Access Compliance Report

Public Rights-of-Way (Curb Ramps)

Intersection ID: 3913	Main Street: WITHERSHINN_DR	Cross Street: HEADQUARTERS_FARM_RD	Location: NE
ADA ID: 8A87F8949FA0	Ramp Type: Perp	Initial Pass/Fail: Fail	Overall Compliance: No
			Severity Score: 33.75

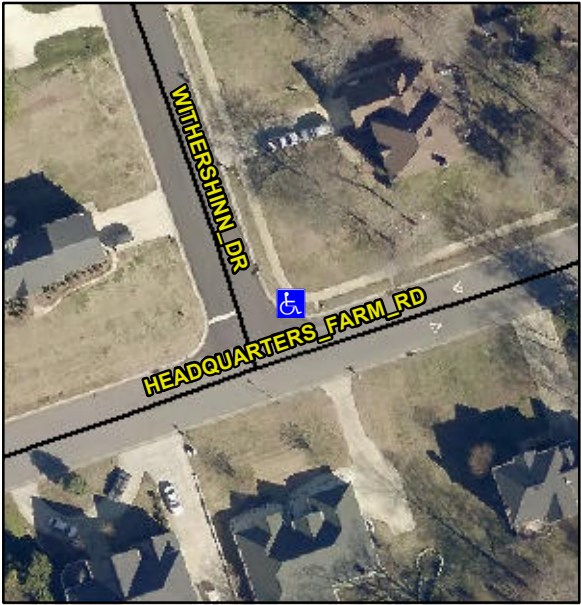
Codes/Mitigation Info/Possible Solution		Field Measurements/Component Compliance			
 <p>Street 1 Name WITHERSHINN DR</p> <p>Stop Condition-Street 2 StopSign</p> <p>Street 2 Name N/A</p> <p>Stop Condition-Street 1 N/A</p>	Possible Solutions:	Remove & Replace Entire Ramp.			
	Surveyor Notes:	N/A			
	PROW/ADA:	Not Found, R304.5.1, R304.2.2, R304.5.3			
			Compliance	Description	Data
			No	Ramp Length (in)	74.0
			No	Ramp Width (in)	37.0
			N/A	Flare Type LT	N/A
			N/A	Flare Slope LT (%)	N/A
			N/A	Flare Traversable LT?	N/A
			N/A	Landing Length (in)	N/A
			N/A	Landing Width (in)	N/A
			N/A	Landing Slope (%)	N/A
			N/A	Landing X Slope (%)	N/A
			N/A	Landing Curb? (Y/N)	N/A
			N/A	Shared Landing?	N/A
			N/A	Gutter Ponding?	N/A
			N/A	Gutter Lip Ht (in)	N/A
			N/A	Painted X Walk1?	No
				X Walk 1 Direction	To W
			N/A	X Walk 1 Width (in)	N/A
				X Walk 1 Slope (%)	8.8
				X Walk 1 X Slope (%)	5.4
			N/A	Ramp inside XWalk1?	N/A
